Addendum No. 6, July 11th, 2025

Re: Johnson Hall Renovation – PKG 3
Johnson Hall Renovation & Foster Demolition
Tennessee Technological University
SBC Project No. 364/011-04-2022CM

A7.30

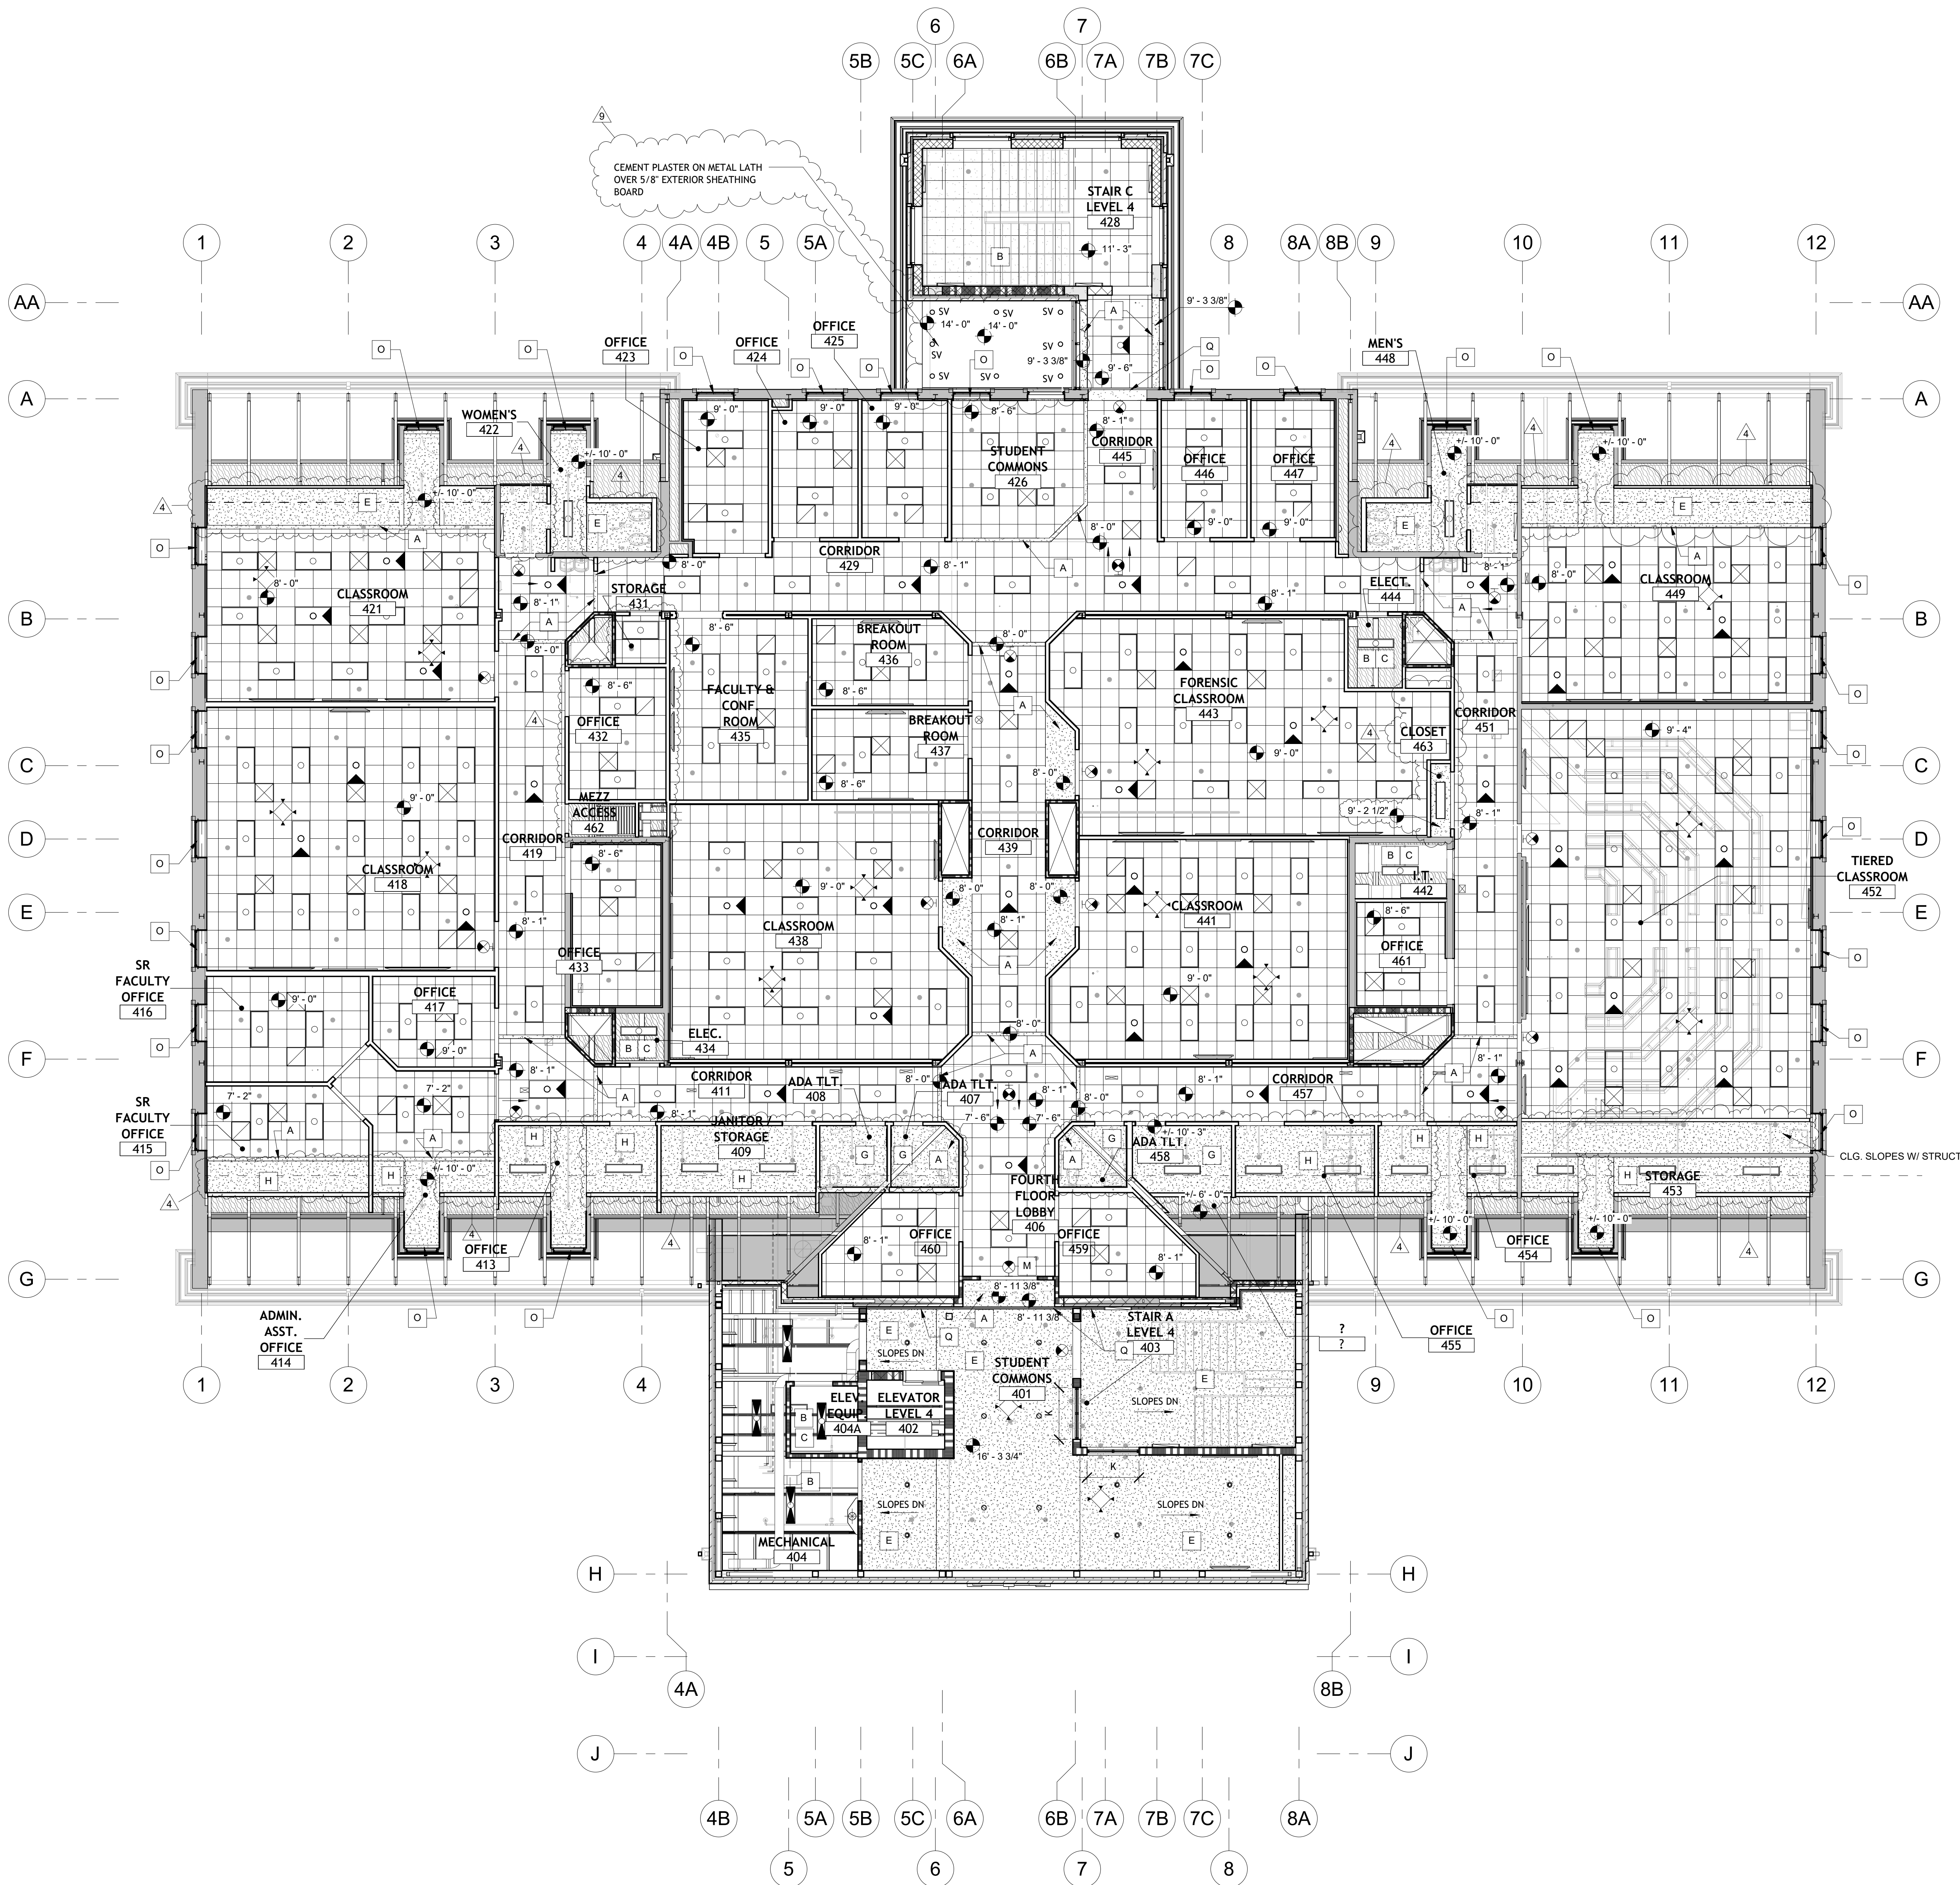
- 15) Refer to sheets A7.10, A7.30 and A7.40. Change soffit at front portico, back portico and above exterior balcony to be a cement plaster on metal lath over 5/8" exterior sheathing board on 20 GA 3 5/8" metal stud framing @ 16" o.c. Add 6" round soffit vents as shown on revised drawings.
